# SUBDIVISION REPORT - CONCEPT

▶ <b>FILE #:</b>	<b>7-SB-21-C</b>	<b>AGENDA ITEM #:</b>	<b>25</b>
POSTPONEMENT(S):	7/8/2021	<b>AGENDA DATE:</b>	<b>8/12/2021</b>
▶ <b>SUBDIVISION:</b>	<b>CAPITAL DRIVE</b>		
▶ <b>APPLICANT/DEVELOPER:</b>	<b>PATRICK SCHAAD TRUSTEE</b>		
OWNER(S):	Schaad Residential Real Estate		
<hr/>			
TAX IDENTIFICATION:	131 122 & 122.24 (PART OF)	<a href="#"><u>View map on KGIS</u></a>	
JURISDICTION:	County Commission District 3		
STREET ADDRESS:	9933 & 0 Kingston Pk.		
▶ <b>LOCATION:</b>	<b>North side of Kingston Pike at Capital Drive</b>		
SECTOR PLAN:	Southwest County		
GROWTH POLICY PLAN:	Urban Growth Area		
WATERSHED:	Sinking Creek		
▶ <b>APPROXIMATE ACREAGE:</b>	<b>2.153 acres</b>		
<hr/>			
▶ <b>ZONING:</b>	<b>CB (Business and Manufacturing)</b>		
▶ <b>EXISTING LAND USE:</b>	<b>Retail store, vacant land</b>		
▶ <b>PROPOSED USE:</b>	<b>Commercial subdivision</b>		
SURROUNDING LAND USE AND ZONING:	North: Vacant land -- CB (Business and Manufacturing) South: Kingston Pike -- OP (Office Park) and PC (Planned Commercial) East: Church -- C-H-1 (Highway Commercial) West: Retail and vacant land -- I-G (General Industrial) and C-H-2 (Highway Commercial)

**7-SB-21-C

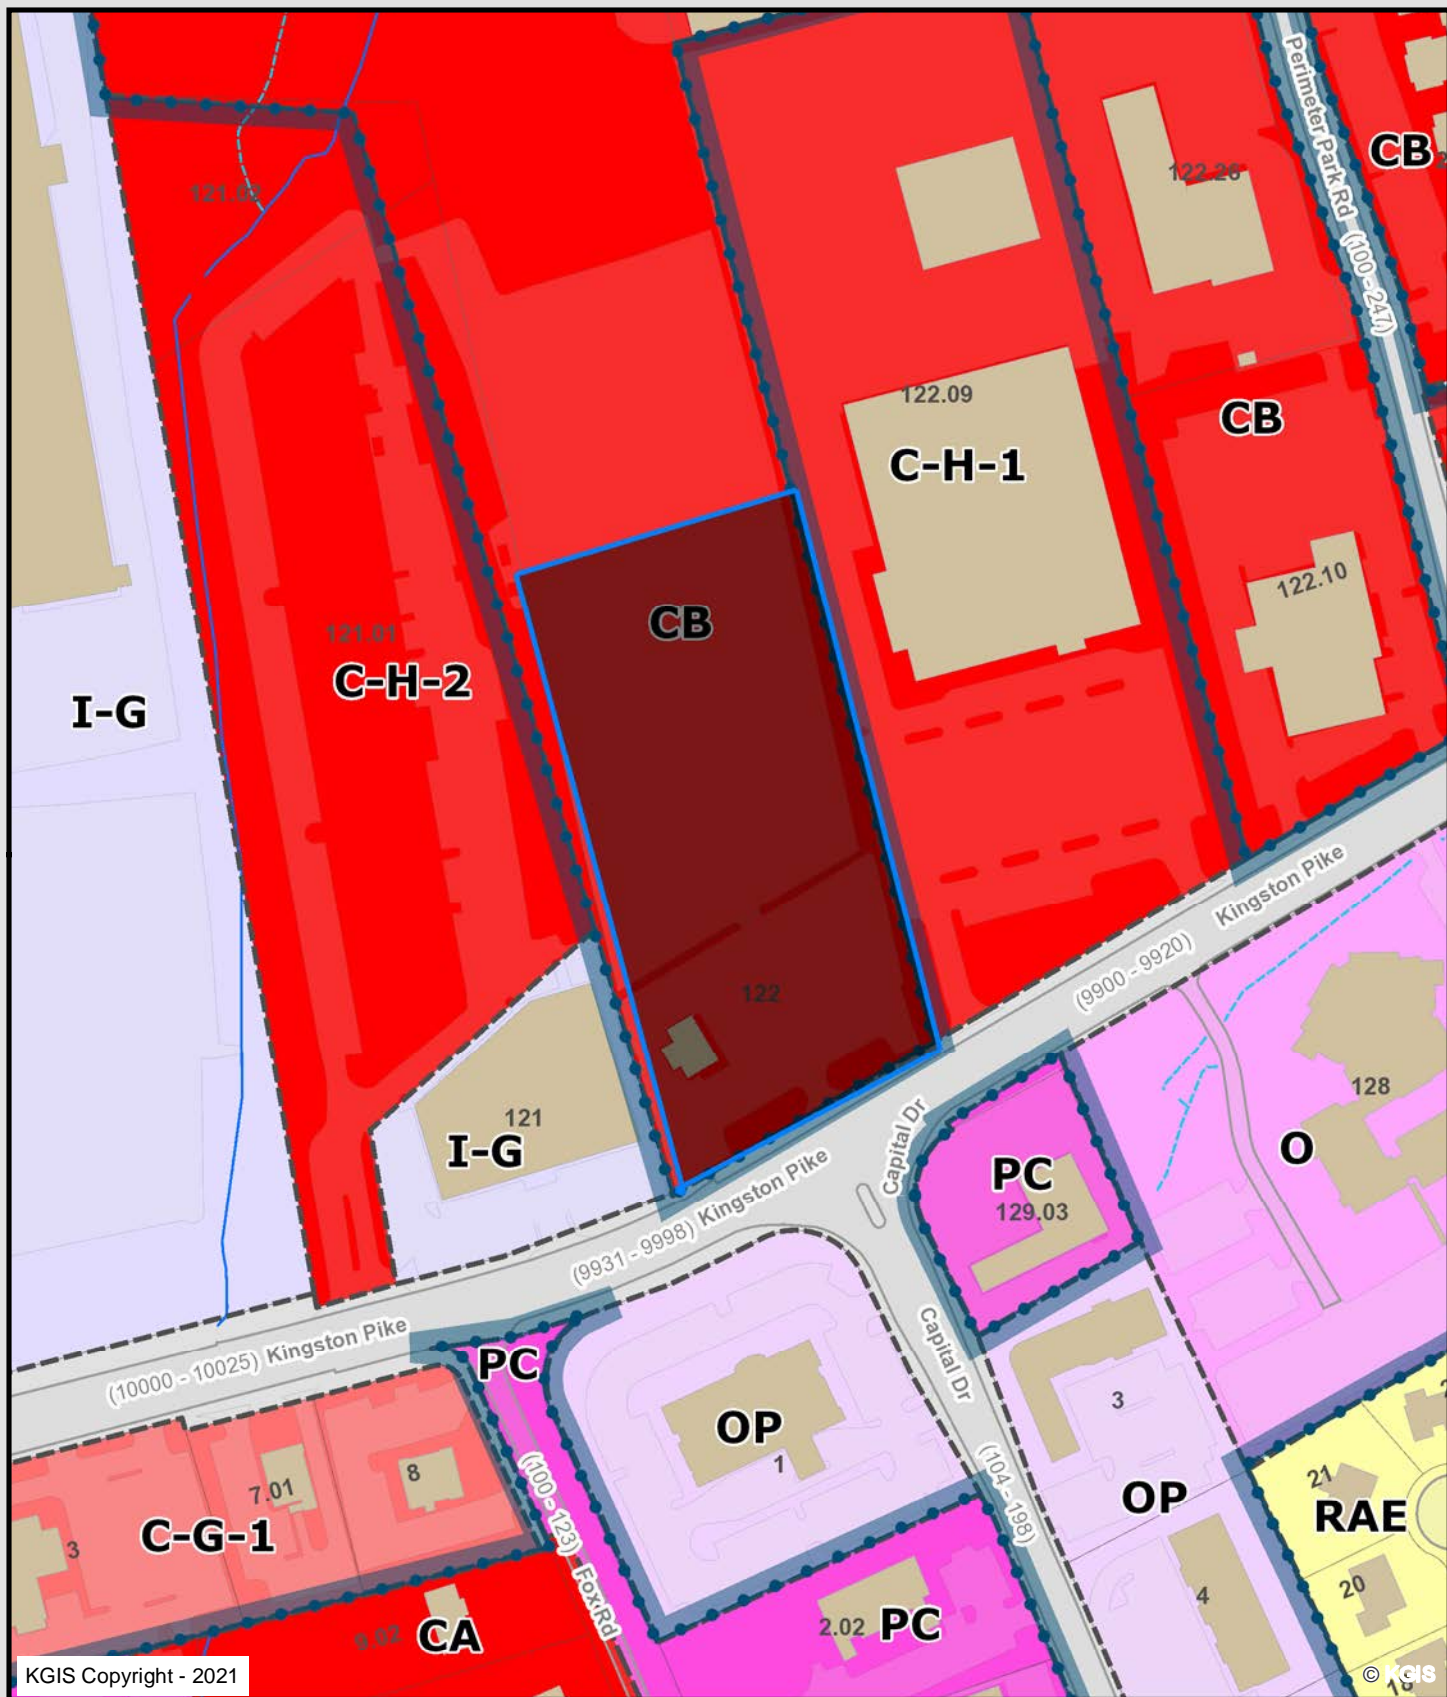
Staff is recommending postponement to allow the applicant time to provide additional details on the concept plan as outlined below:

- 1) Show all major recommendations of the Capital Drive-Kingston Pike Retail Development Traffic Impact Study (CDM Smith, revised June 21, 2021) on the concept plan (see Exhibit A), including the reconfiguration of the northbound approach on Capital Drive.
- 2) Provide a preliminary detention pond plan for Lot #4 to demonstrate that the parking lot for the existing retail store (GemStore) can remain in compliance with the zoning standards.

The traffic signal at this Kingston Pike intersection must be modified to accommodate the new road and the Capital Drive intersection on the south side of this intersection needs to be reconfigured to function properly with the addition of the new road. When Capital Drive was constructed, it was in Knox County and was subsequently annexed into the City of Knoxville. There is a landscape island with a directory sign for the office development in the middle of Capital Drive at the Kingston Pike intersection. It is unknown when this sign was installed but it and the landscape island are in the public right-of-way and must be removed as part of the intersection improvements to create a dedicated left-turn lane.

The City of Knoxville requires sidewalks to be installed along road frontages when a property is developed or redeveloped, so a sidewalk along the Kingston Pike frontage is required. The developer can make a formal request to the City of Knoxville Director of Engineering for a waiver to this requirement, however, this has not been requested as of the publication of this staff report and there is no guarantee this waiver will be approved. The existing detention ponds on lots 1 and 4 will be modified with the installation of the new road, however, the concept plan does not show a preliminary design for these modifications. The primary concern is how the pond on Lot 4 will impact the parking lot design for the existing business.

► **Postpone the Concept Plan application until the September 9, 2021, Planning Commission meeting as recommended by staff for the reasons listed below.**
